TO: Mercedes-Benz Dealer Principals, General Managers, Sales Managers, Service Managers, Parts Managers	FROM: Gregory Gunther, Senior Manager, Vehicle Compliance and Analysis, Engineering Services
RE: <b>Recall Campaign Launch Notification</b> <b>Inspect 12V Starter/Alternator Wiring Harness</b> <b>MY22-23 SL (232 platform)</b>	DATE: November 3, 2023

Campaign No. 2023100014, November 2023

SUBJECT: **Model SL (232 platform)**  
**Model Year 2022-2023**

## **Inspect 12V Starter/Alternator Wiring Harness**

**Figure 1:** Inspect starter/alternator wiring harness near propeller shaft (**arrow A**), direction of travel (**arrow B**)

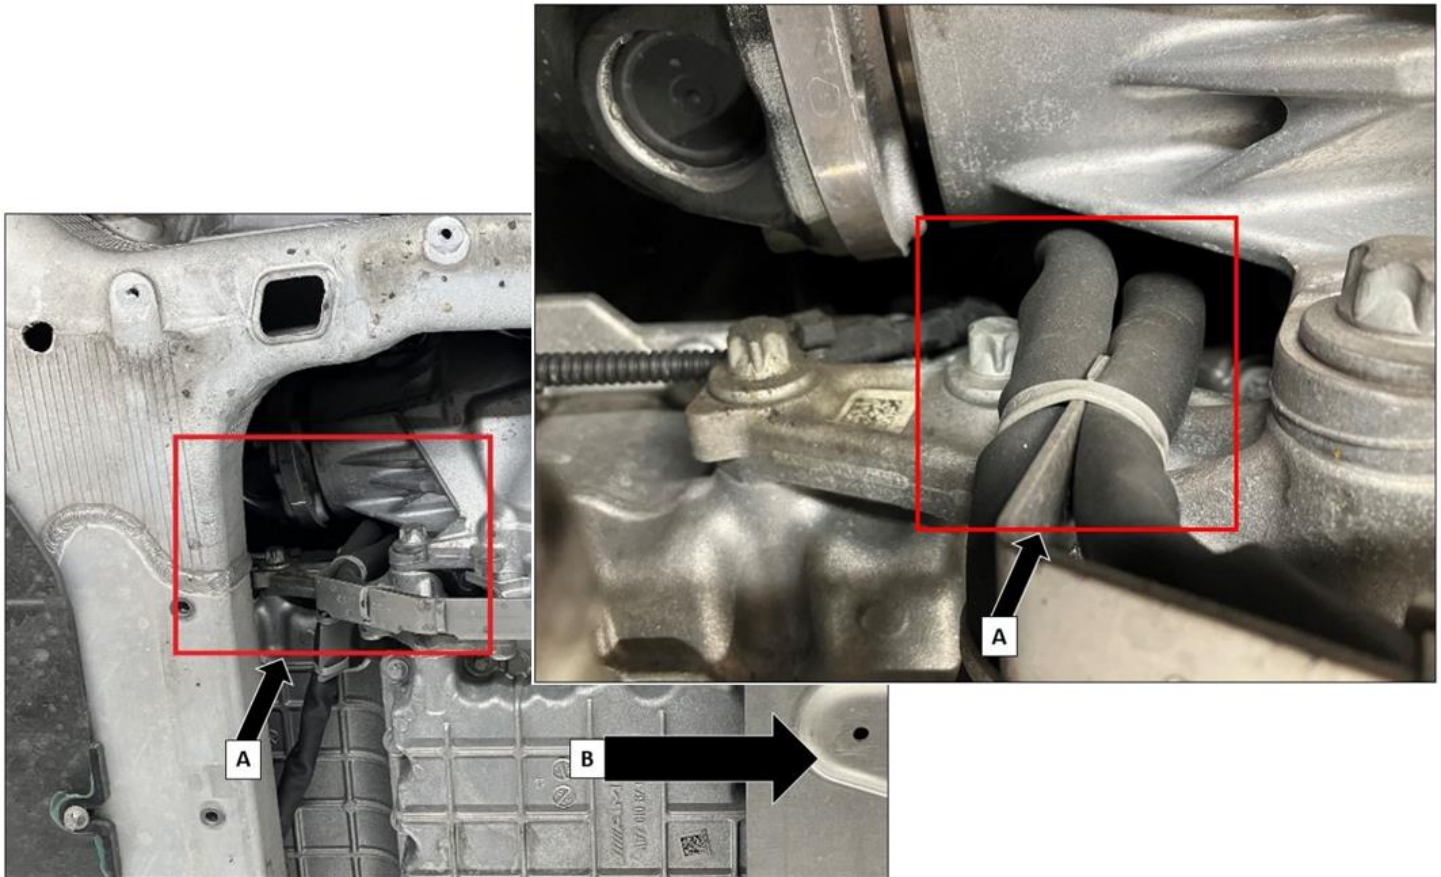
2. Check if the 12V starter/alternator wiring harness is too close to the propeller shaft and inspect it for damage near the propeller shaft (**A, Figure 1**).

- a. Starter/alternator wiring harness **not damaged**, carry out **Work Procedure 1**.
- b. Starter/alternator wiring harness **damaged**, carry out **Work Procedure 2**.

**Figure 2:** Install cable tie on starter/alternator wiring harness

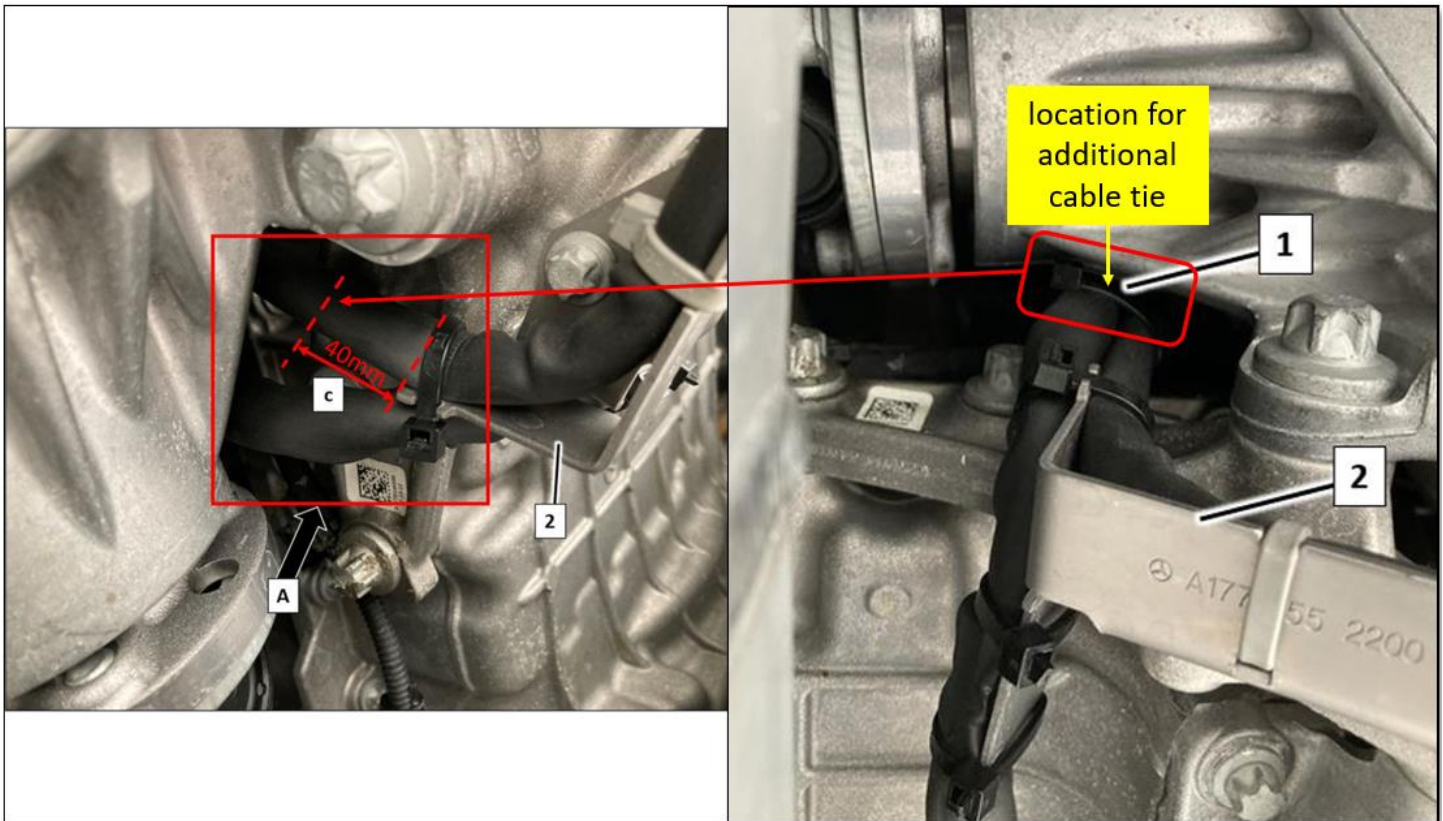
1. If the starter/alternator wiring harness is **not damaged**, install an additional cable tie (1, **Figure 2**) in area near the propeller shaft at approx. 40 mm (**dimension c, Figure 2**) above the bracket (2, **Figure 2**).
